Rezoning Transportation Analysis

Petition Number: #2022-091

Date	Description
11-28-22	First Review (IW)
01-27-23	Second Review (IW)

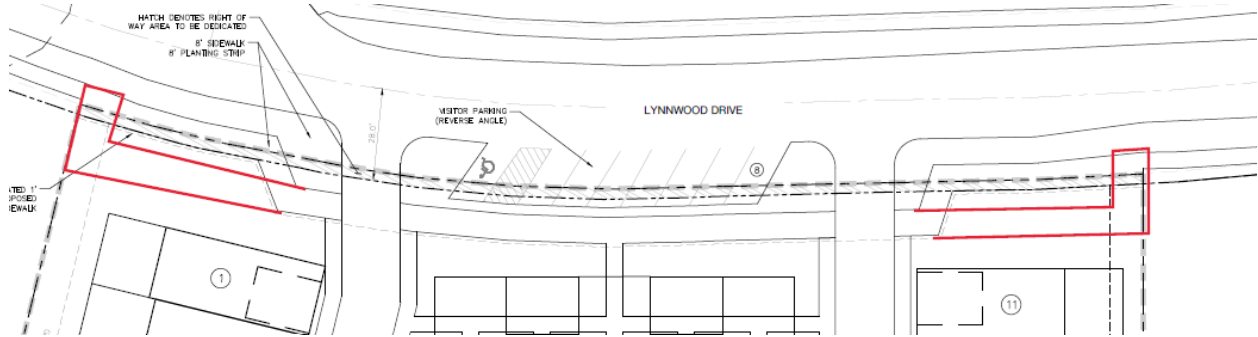
- ~~3. Revise conditional note(s) to commit to dedicate 28 feet of right of way from the road centerline in coordination per CLDSM Local Residential Medium Street. The site plan shall label and dimension the right of way from the road centerline.~~
4. Revise site plan and conditional note(s) to remove angled parking and install parallel parking on Lynnwood Drive.

Comment Clarification 01-27-23: CDOT is comfortable with the reverse angled parking given context of the existing street network and neighborhood development. Add conditional note stating that appropriate signage for reverse angle parking will be coordinated with CDOT during permitting.
